**RE: Stokes Estate
Conditional Use Review
Westtown Township
WTT-21-228**

This letter is in response to the June 30, 2023 Cedarville Engineering Group, LLC (CEG) review of the above referenced Plans by D.L. Howell and Associates, Inc.

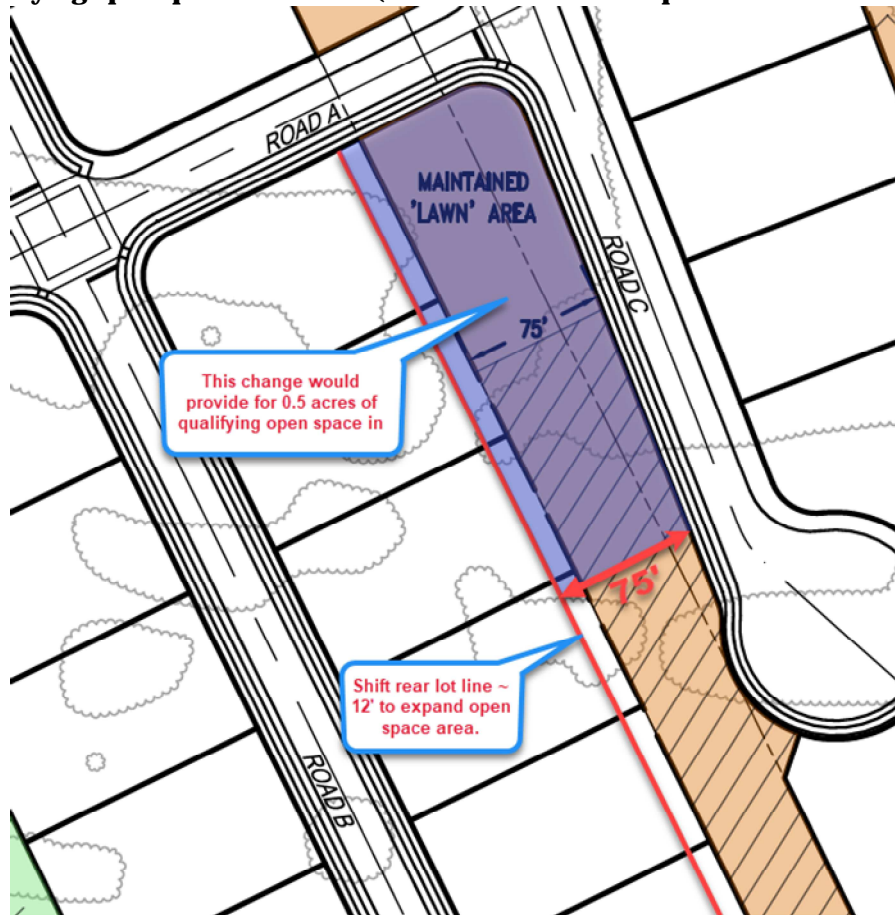
- Per the above referenced Ordinance section, qualifying Open Space shall consist of an area of ½ acre or more, and shall be contiguous to qualifying Open Space. The acreage of the area shown as "Maintained Lawn Area" and as qualifying open space, to the rear of Lots 32 and

33 shall be provided to demonstrate compliance with the referenced Ordinance requirement.

Howell Response: Zoning Ordinance Section 170-907.A.(7)(a) states: The following design standards, as deemed appropriate by the Board, shall apply to areas of common open space. Such areas shall be not less than 75 feet in width at any point and not less than 1/2 acre of contiguous area. Based on this language, we do not see a requirement for qualifying open space to be 1/2 acre of contiguous area, but rather that the qualifying open space be part of 1/2 acre of contiguous open space. The proposed qualifying open space in this location is less than 1/2 acre, but it is part of a contiguous open space area that exceed the minimum 1/2 acre in size, therefore we feel it meets the requirements and intent of the code. However, if the Township Engineer's interpretation is assumed to be correct, adjustments to the open space can be made in order to provide at least 0.5 acres of qualifying open space in this area (as shown in the markup below).
